## Request for Proposal, 22MCO596

### In response refer to RFP No. 22MCO596 Addendum 3 and Response to Questions September 13, 2021

<b>MIDLAND COUNTY PRECINCT # 1</b> <b>SOUTH COUNTY ROAD 1270 - PHASE 2</b> <b>MIDLAND COUNTY, TEXAS</b>	DA PROJECT B005667.001
<b>TYPICAL PAVEMENT SECTIONS</b>	SHEET <b>2</b>

**ROAD SECTION STA 230+75 - 234+00**  
NOT TO SCALE

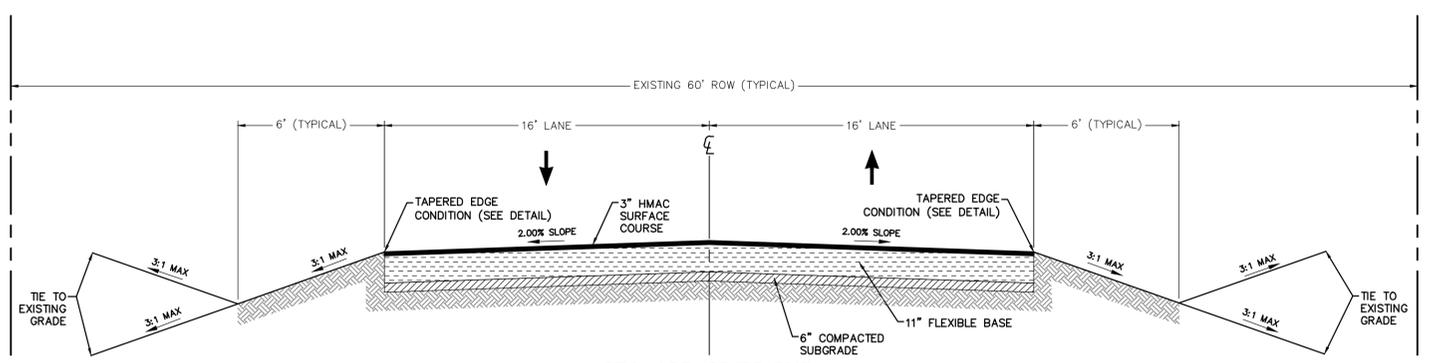
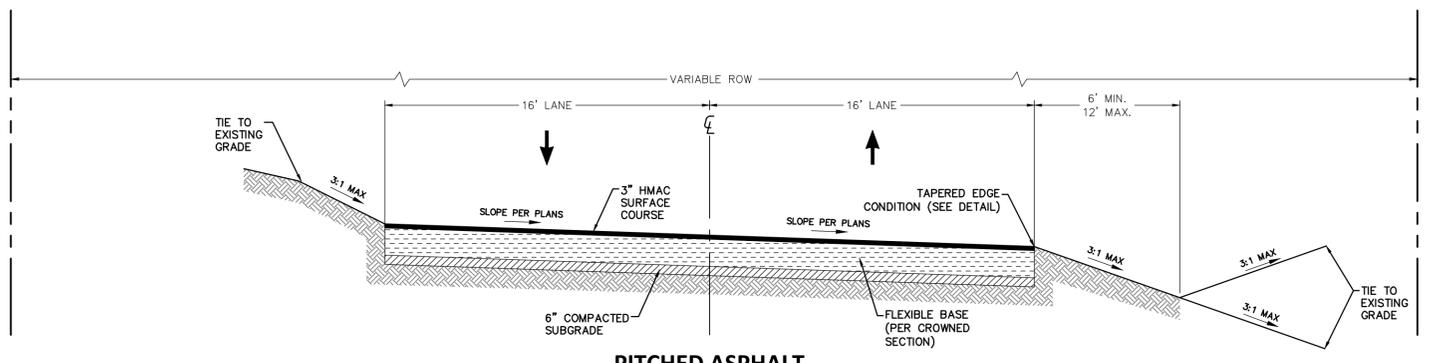
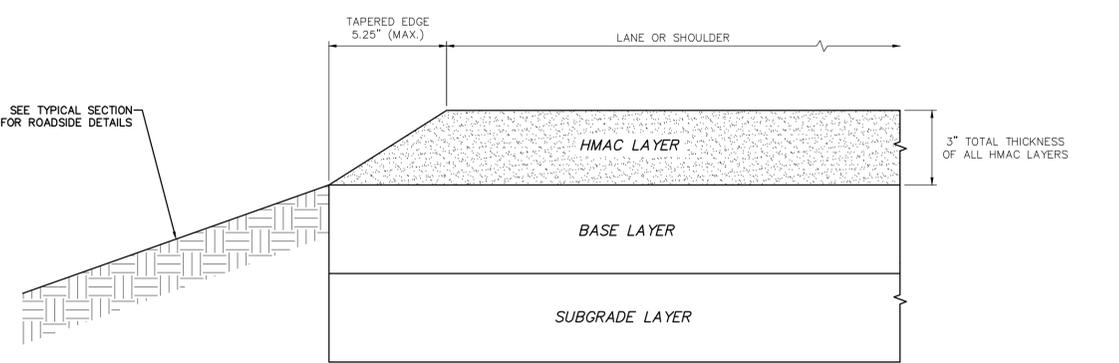
4. Please Provide a jointing plan for the slab on top of the boxes of the Culvert structure.  
Jointing plan is on Sheet 2 and the stationing has been corrected from STA 23+75- 234+00 to STA 230+75 -234+00.

NO.	REVISION	BY	DATE	CHECKED
1	CORRECTED STATIONING	JAS	09/13/2022	JLB
				DESIGNED
				JLB
				DRAWN
				JLB
				CHECKED
